# Wallarrah 2 Coal Project

## Residual Matters Report

October 2013

**Figure 1**  
Post mining impacts on Wyong River Weir Low Flow Threshold Flow Duration Relationship (1972-2013)

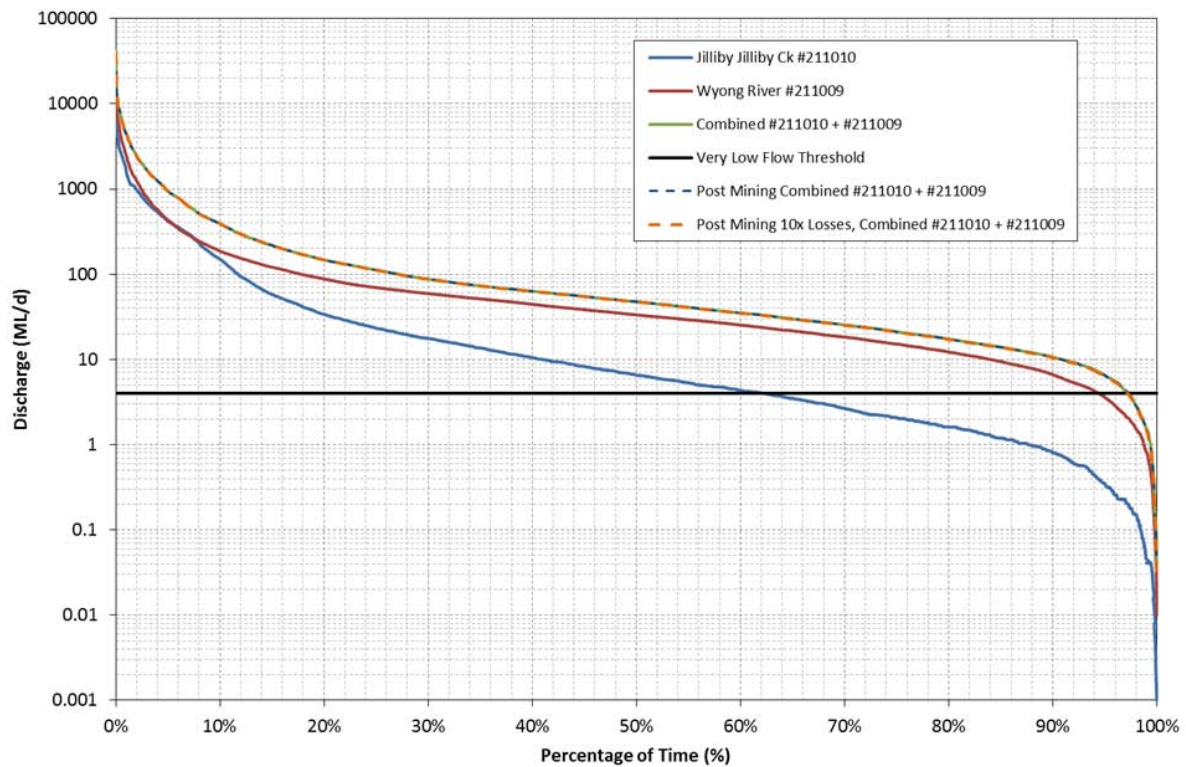
Section 17(a)(ii)(A) of the Central Coast Unregulated Water Sharing Plan outlines the Very Low Flow Class for the Wyong River Water Source for all local access water utility access licences as being “when the combined flows at gauging stations 211009 and 211010 are equal to or less than 4 ML/day”. Each of these gauging stations has 40 years of historical record (since 1972). **Figure 1** shows the flow duration relationship at each gauging station for the last 40 years, as well as the flow duration curve for the combined flows.

To test the sensitivity of the losses, the same analysis was undertaken assuming the losses were increased by a factor of ten. The results are also presented in **Figure 1**. The results indicate that if the losses were out by a factor of ten, the period in which discharges are in the ‘Very Low Flow’ Class of the Wyong River would increase by 14 hours/year.

A similar assessment was undertaken for 2006 (the lowest annual streamflow on record) to assess the impacts during drought conditions. Results are shown in **Figure 2**. Results indicate an increase of 5.1 hours/year of discharges in the ‘Very Low Flow’ Class under drought conditions.

**Figure 3**  
**Comparison of Wyong, Wallsend and Beresfield PM2.5 Data (2012-13)**

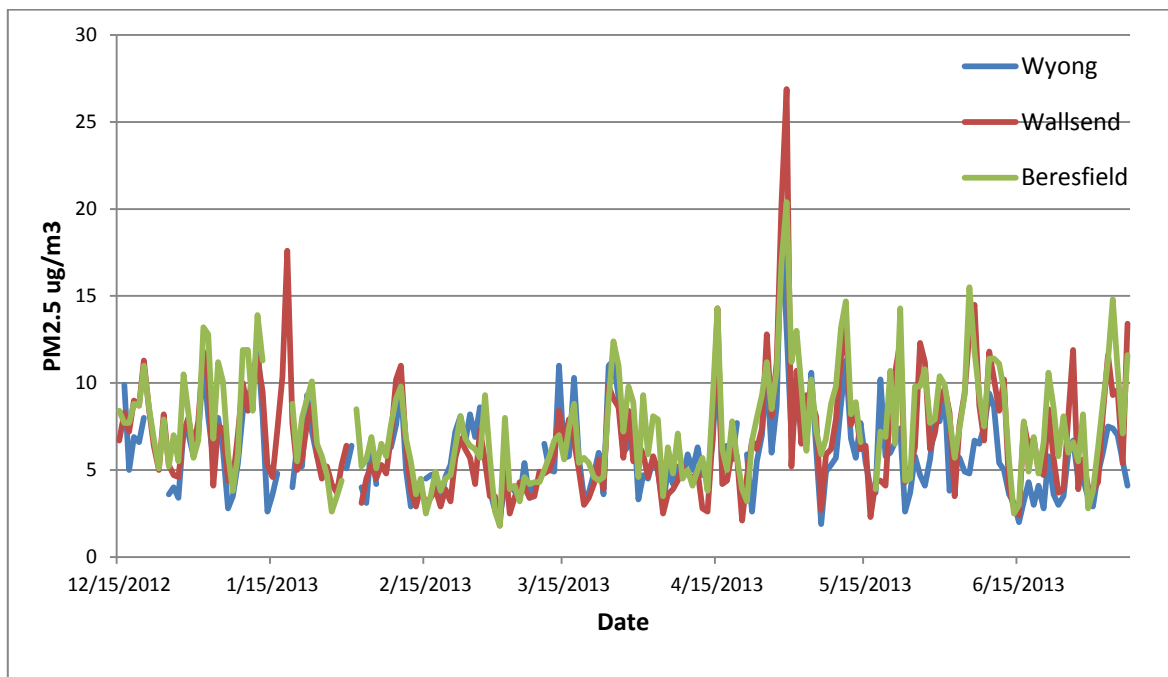
*The predicted increase in PM concentration at the nearest receptors is small and so the associated health risk is also likely to be small. However, the information provided by the proponent in section 3.7.2 of the response to submissions is not sufficient for an objective assessment to be made of the validity of the results presented in table 3.*

*To facilitate objective assessment, the proponent would need to provide clear and detailed information about the inputs to their calculations including:*

To assess the health risks associated with the Project, background data was obtained. The EPA established a monitoring site for PM<sub>10</sub> and PM<sub>2.5</sub> in Wyong in late 2012. For the EIS, there was insufficient data to be used in the HRA. PM<sub>2.5</sub> is monitored at two sites in Newcastle (Beresfield and Wallsend) as well as at Richmond. This data was compared with the available data from Wyong to evaluate whether any of these data sets would be suitable for use for the Project. The Richmond data was significantly higher than either the Newcastle or Wyong sites and was considered unsuitable.

As can be seen from **Figure 3**, the PM<sub>2.5</sub> data at the two Newcastle sites is similar to the data collected at Wyong for the same period with the data from the Beresfield site being more similar. On this basis, in the absence of data being available for Wyong, the Beresfield data was used as background data in the HRA.

HB 1163 F01 Wallarah RTS - Wallarah Ck Disturbed Catchment.dwg

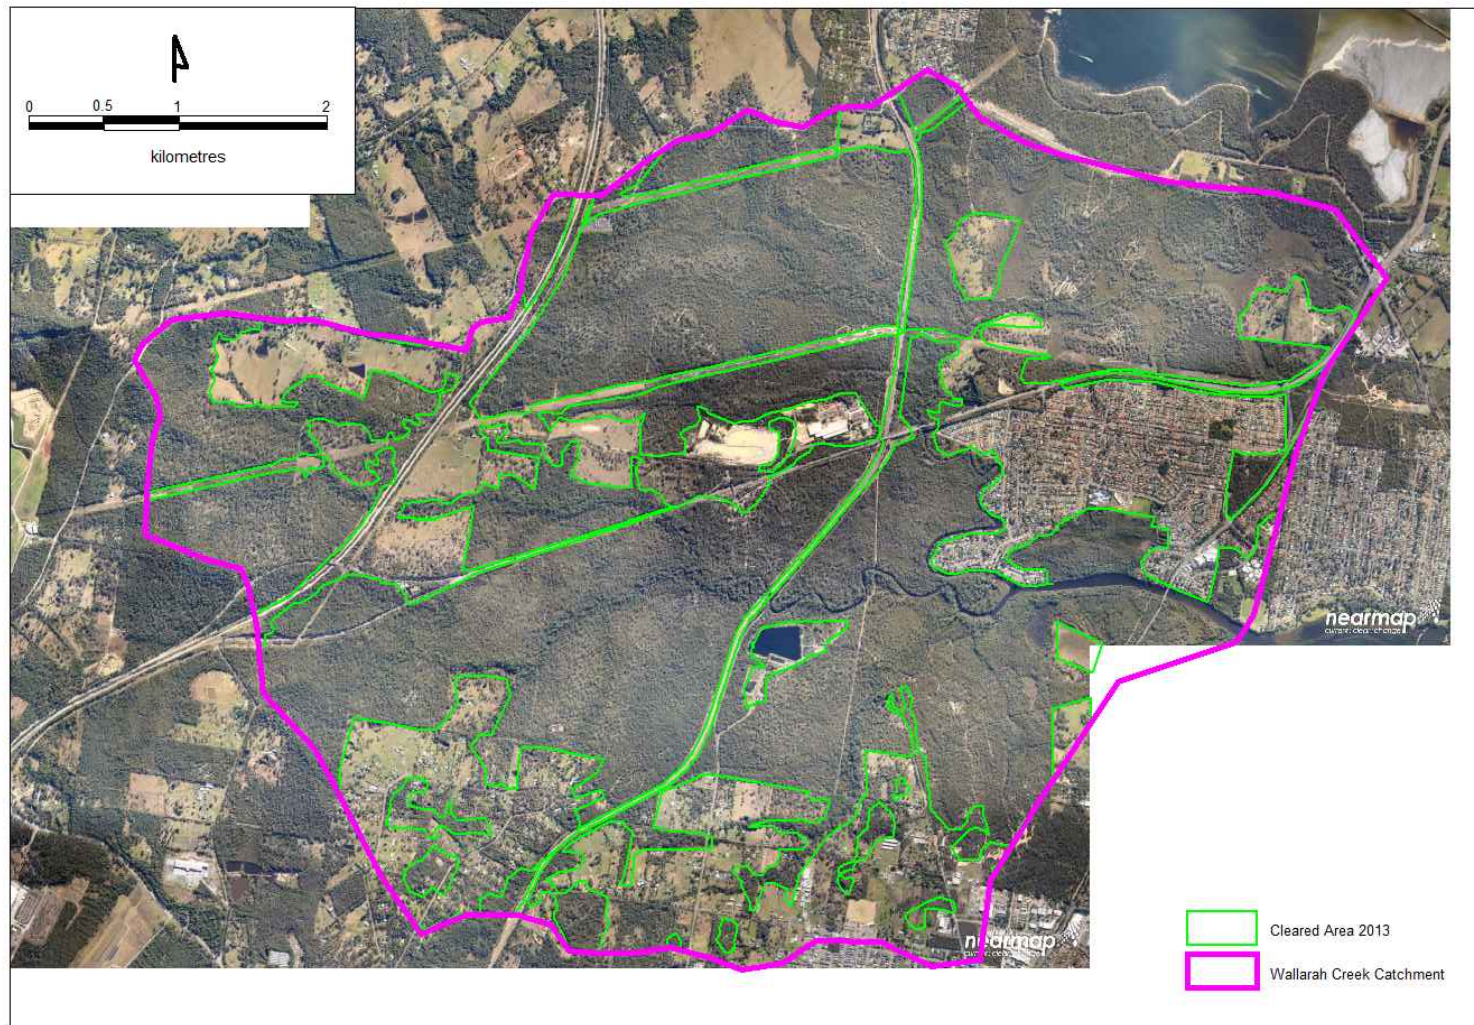
*Wallarah Creek Data. The proponent needs to clarify the percentile level of the data quoted under the column heading "80th Percentile Value" in the preliminary discharge limits table. Same values have been tabulated as 90th percentile in Appendix J, Table 2.11".*

*The discharge limit cannot exceed ANZECC trigger value for toxicants listed in the preliminary table provided.*

The approach to the selection of discharge limits was as described in the ANZECC guidelines, Section 3.1.1.2 regarding determination of appropriate guideline trigger values: "For physical and chemical stressors and toxicants in water and sediment, the preferred approach to deriving trigger values follows the order: use of biological effects data, then local reference data (mainly physical and chemical stressors), and finally (least preferred) the tables of default values provided in the Guidelines." This approach was reiterated to us in a teleconference with David Bell (Regional Operations Officer, NSW Environment Protection Authority) on 6 August 2013.
